Re: Food Lion - Rockwall, Final Plat

FOOD LION SITE PLAN - FM 740/FM 3097 AREA

Re: Response to Final Plat Review

Agenda Item: P&Z 90-30-FP - Discuss and Consider Recommending Approval of a Final Plat for Food Lion Grocery Store on FM-740

FOOD LION ~ ROCKWALL
AN ADDITION TO
THE CITY OF
ROCKWALL, ROCKWALL CO.,
TEXAS
E. TEAL SURVEY, ABST. NO. 207
SEPTEMBER, 1990

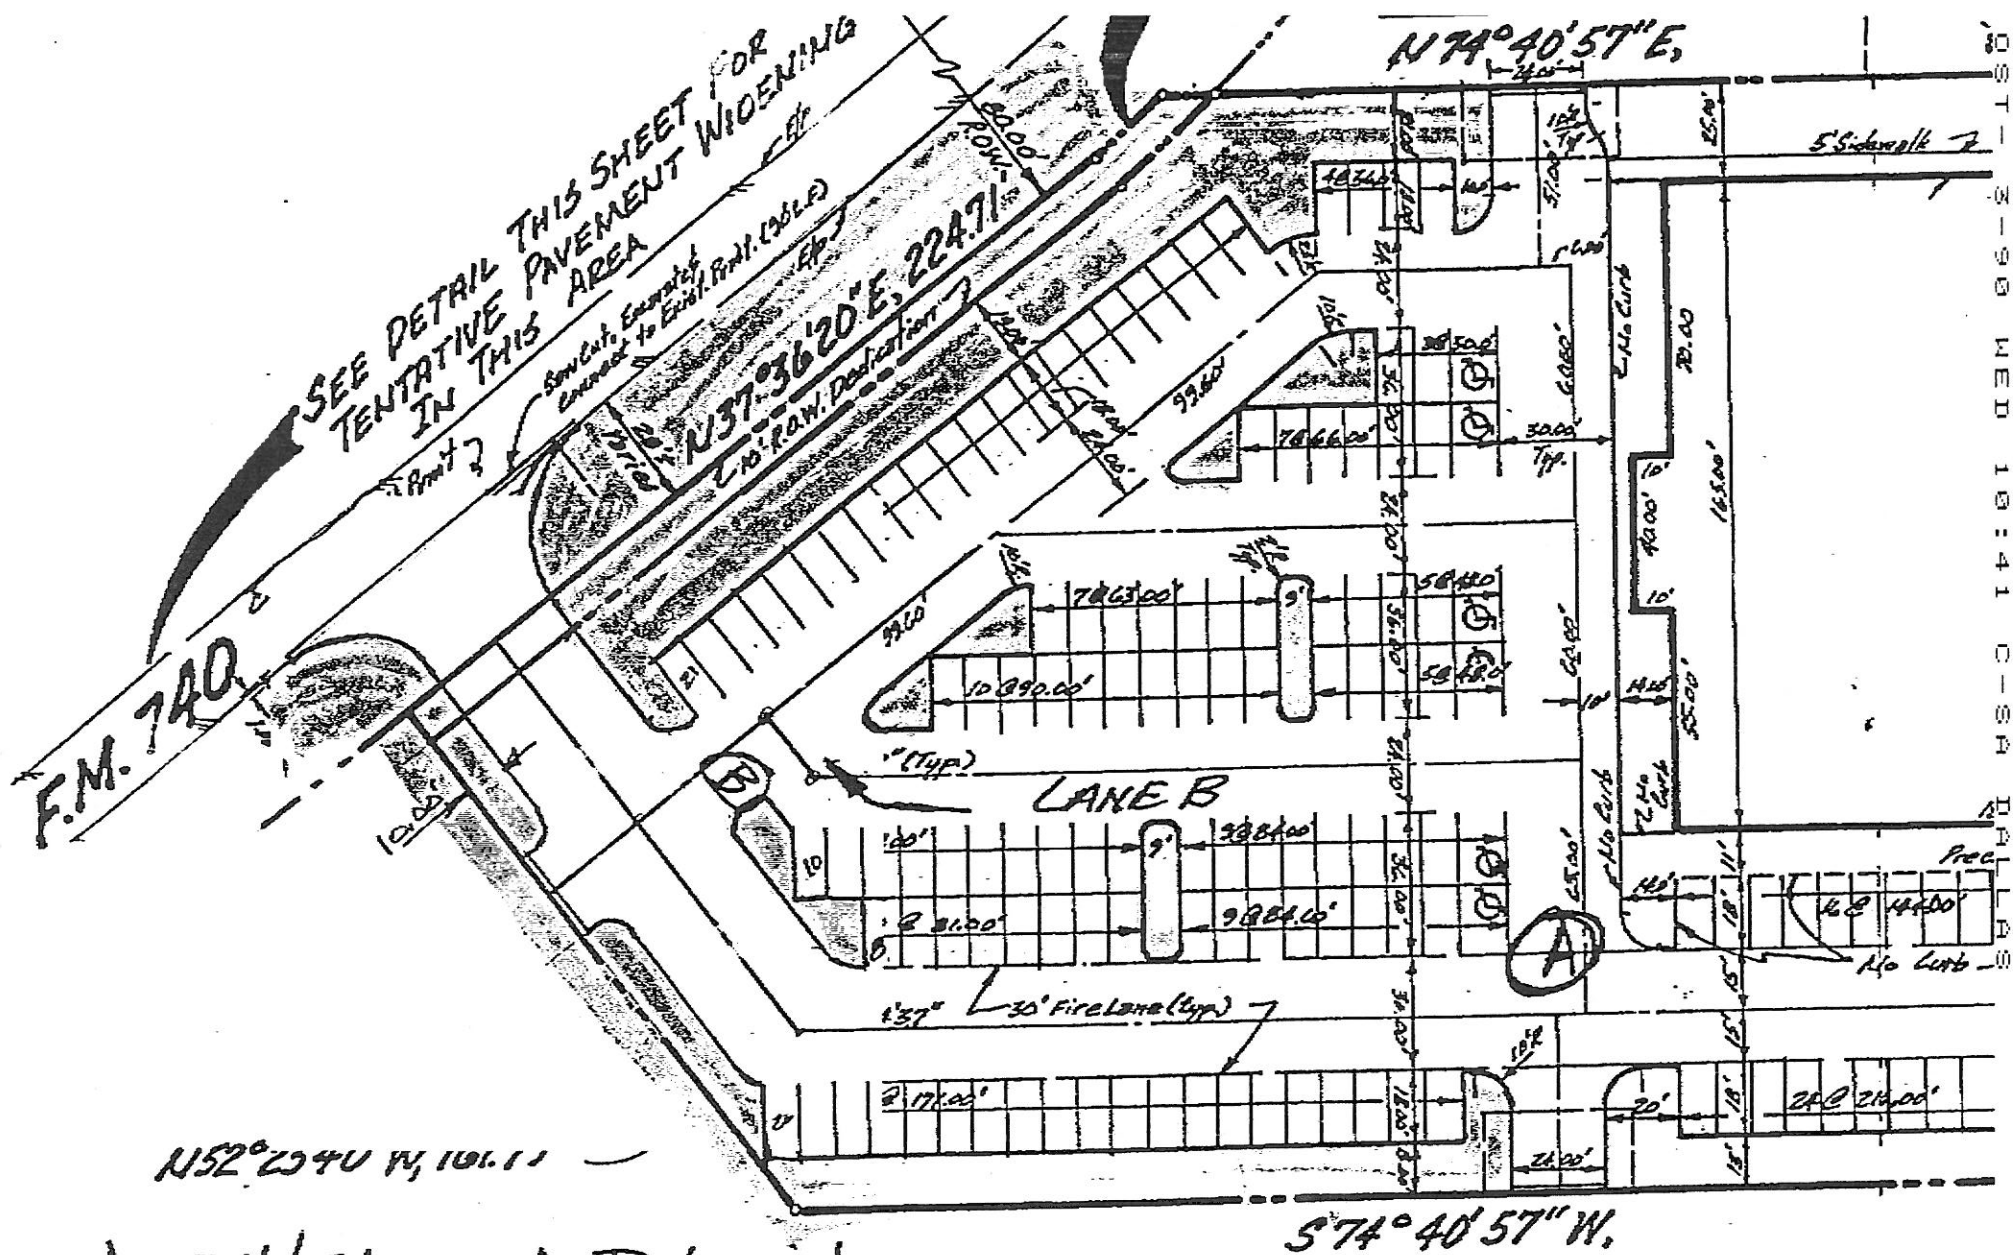
1. Correct the name of the plat
2. Correct the ROW dedications on both FM-740 and FM-3097
3. Identify the point of beginning
4. Add Lot 1, Block A to the plat
5. Please provide documentation that the easements for access conform to the site plan. They don't appear to do so on this draft.
6. Add "Recommended for Approval" above the Planning and Zoning Chairman's signature.

We are in concurrence with your Six Point Final Plat Revision Recommendation. All six comments will be addressed appropriately.

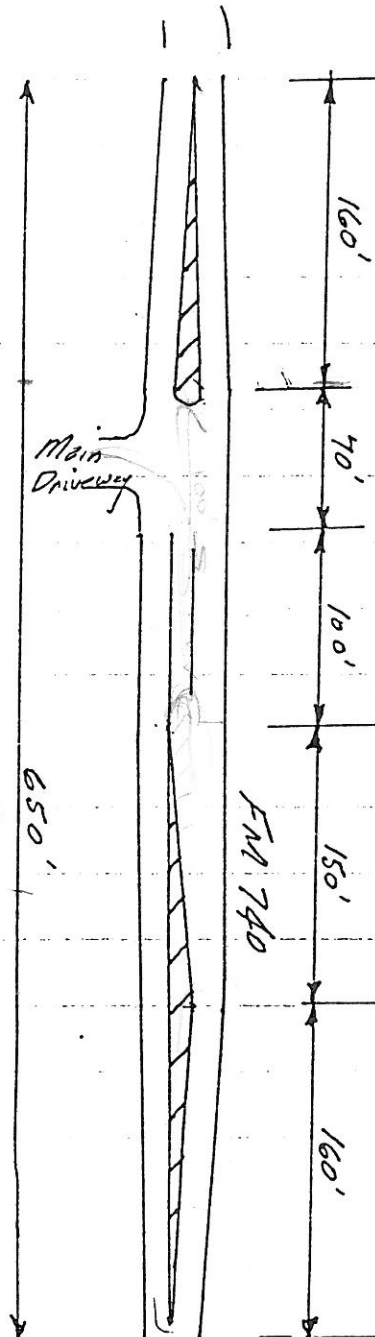
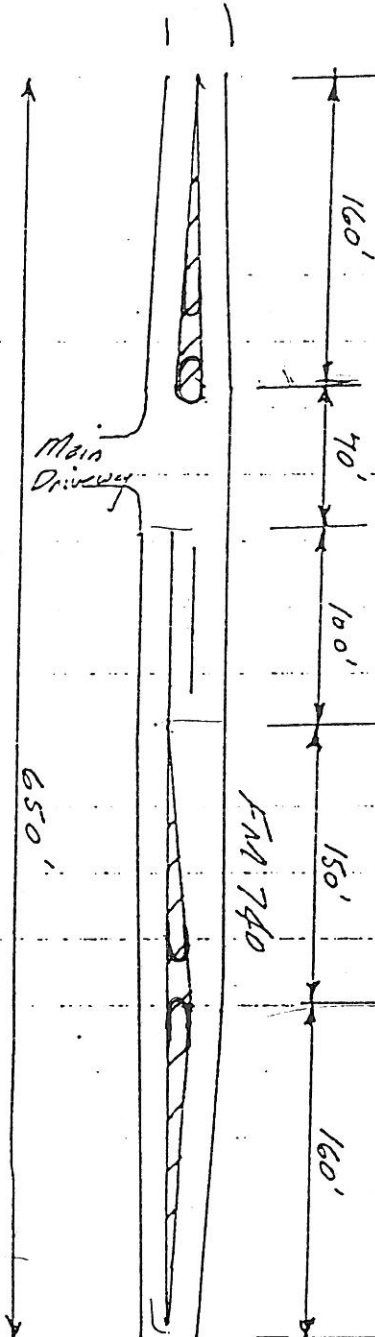
3. The design for FM 740 as proposed by the developer, is inadequate. The transitions are too abrupt for a design speed of 40 mph, the storage length is too short, and the median opening is also inadequate. The design shown accomplishes all of the widening along the west side of FM 740 - this is not recommended because it requires longer transitions.

4. The recommended left turn lane design is shown on the attached sketch. It widens the roadway by 12 FT, centered about the centerline of the existing road. If all of the widening must occur along one side, the transition lengths become 320 FT each, instead of 160 FT. It should be pointed out that incorporation of this design will begin the transition north of the Mr. M driveway. Because of this, the transition in this area may have to be lengthened more to provide adequate guidance to southbound motorists.

Design based upon
• 40 mph design speed
• widening on both sides
of existing centerline

Design based upon
• 40 mph design speed
• widening on both sides
of existing centerline.

RIDGE ROAD (F.M. RD. 740)

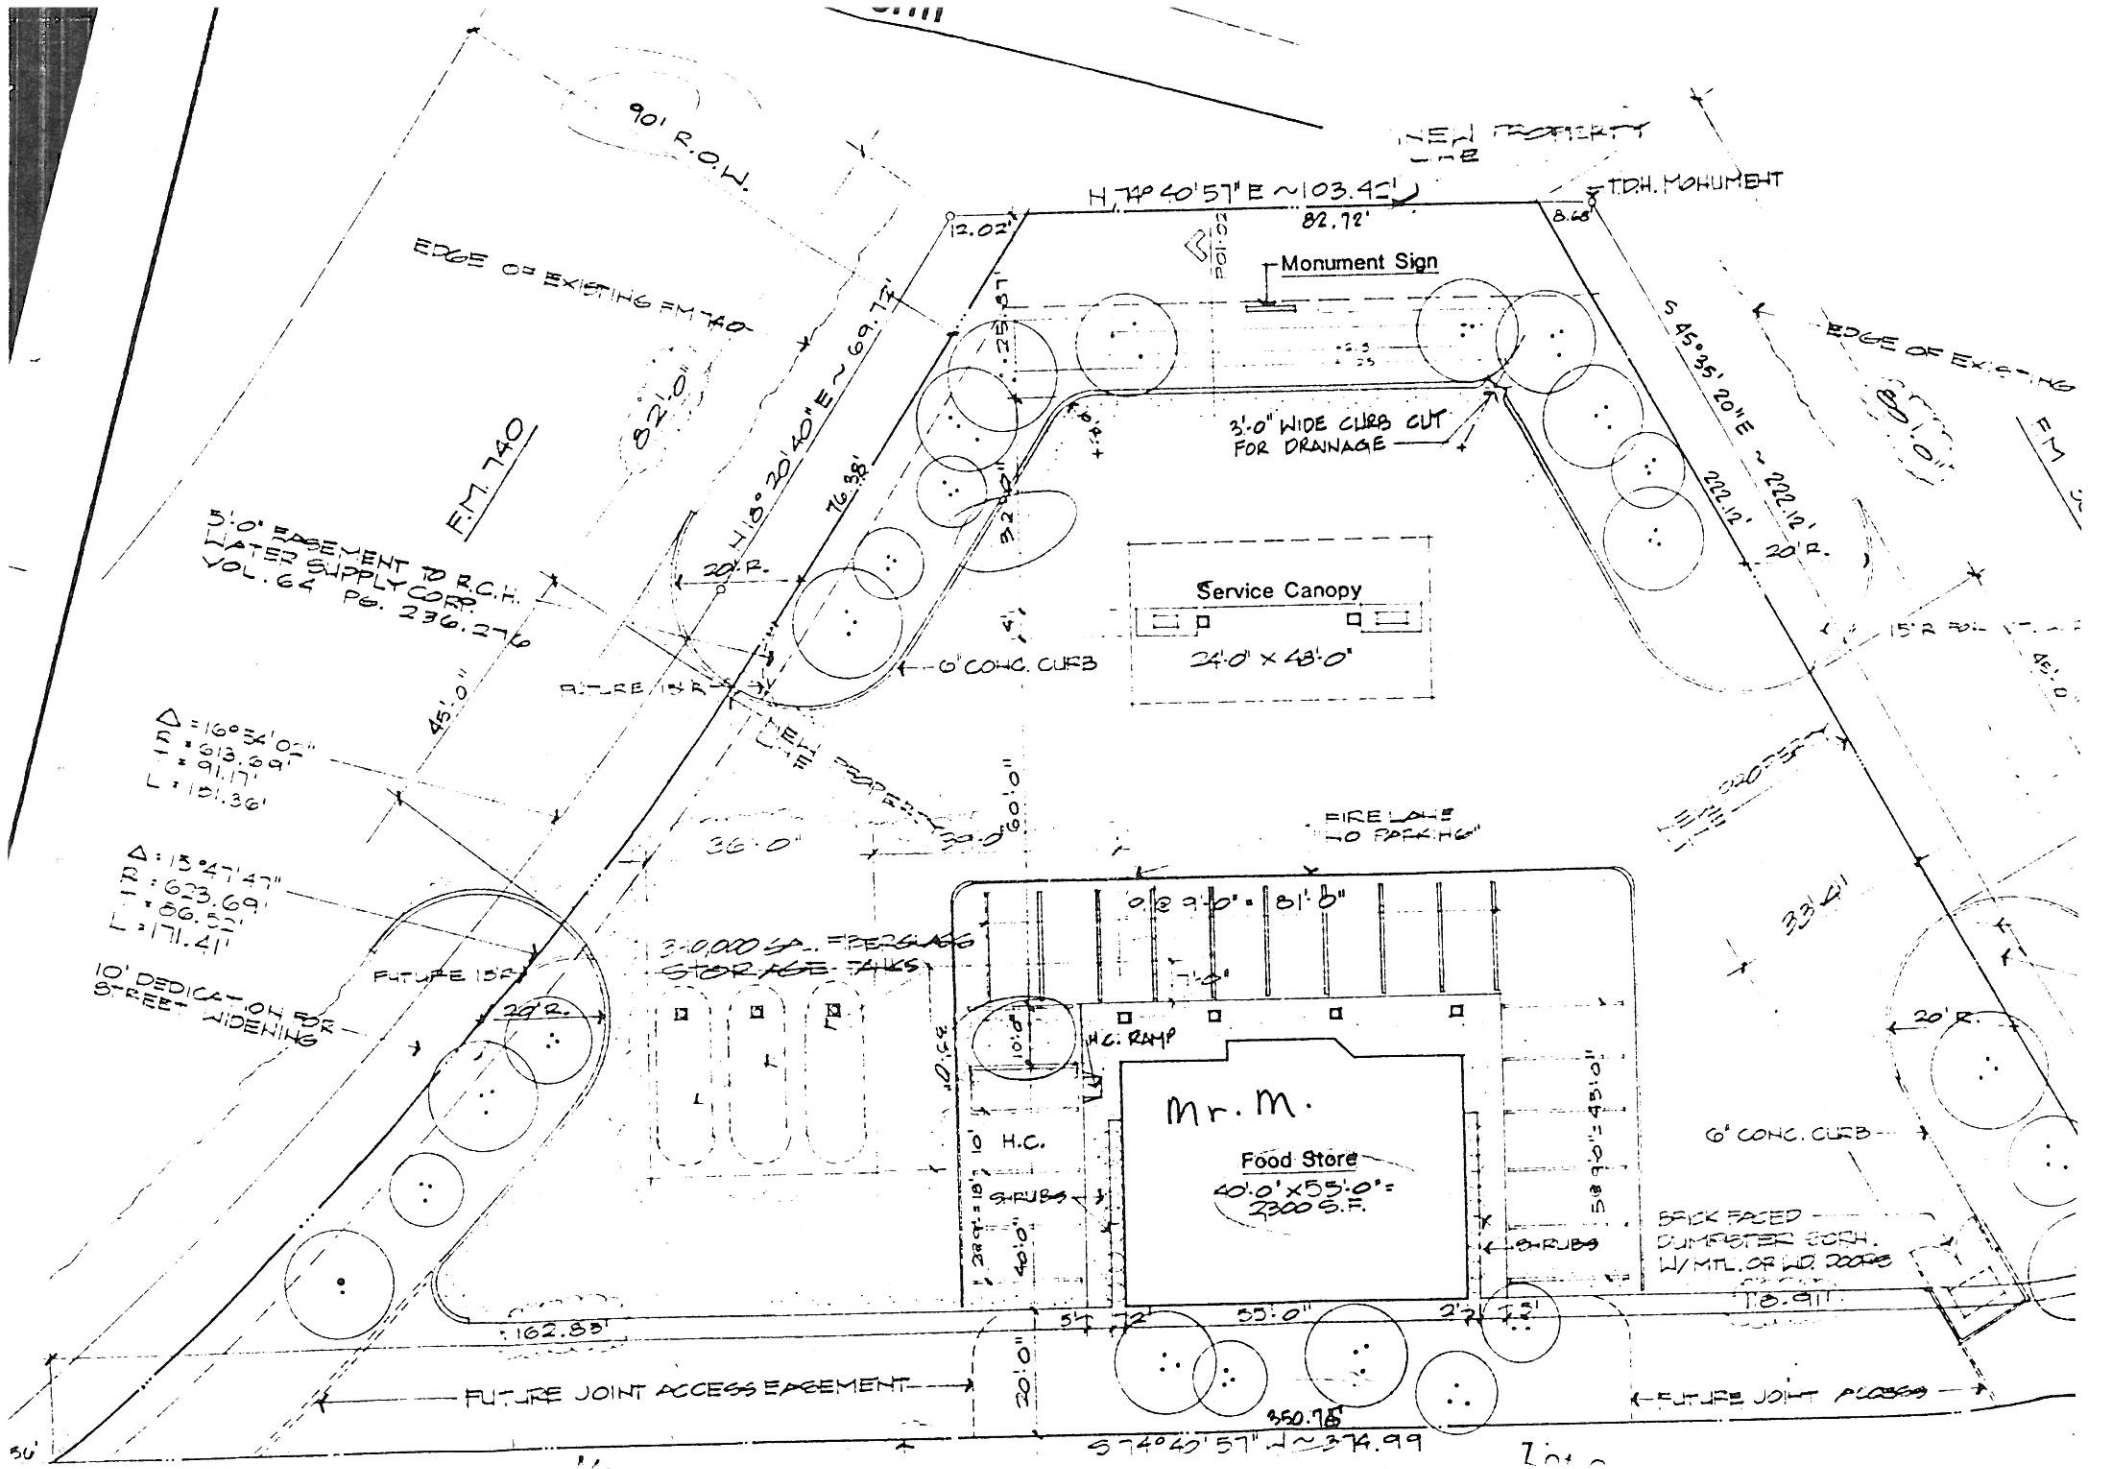
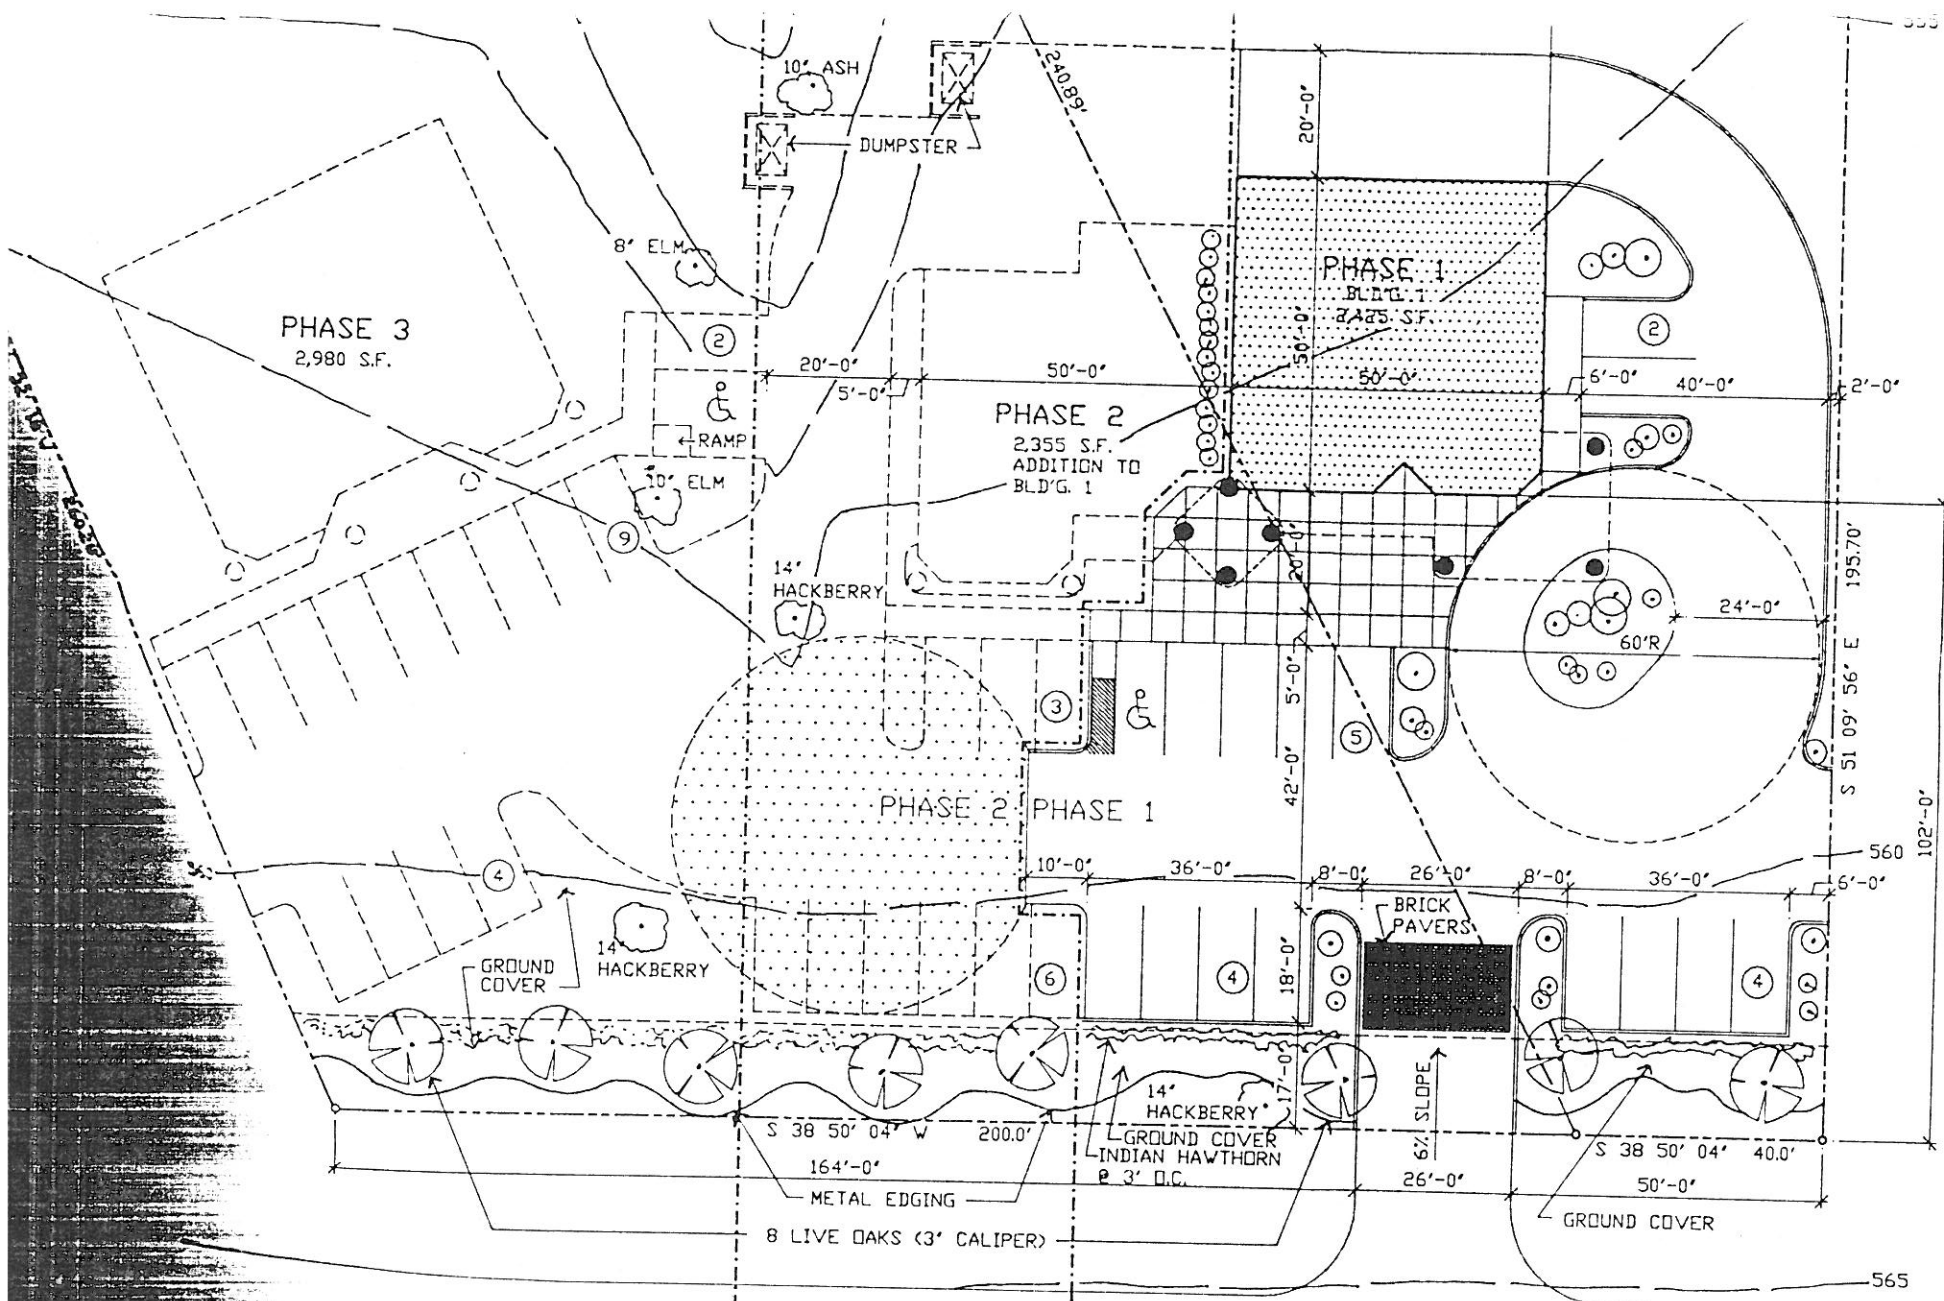
In regard to the turn lane on FM-740, as we discussed on the phone, we will want to look at providing some spacing in the striping for the Mr. M store to the north and the cleaners being constructed just south of your site. Attached you will find a copy of the site plan for the Mr. M site and the cleaners so that you can identify their driveway locations on your turn lane drawing. A width of approximately 40 feet should be used for the striping spacing. I have also attached a rough sketch of this concept.
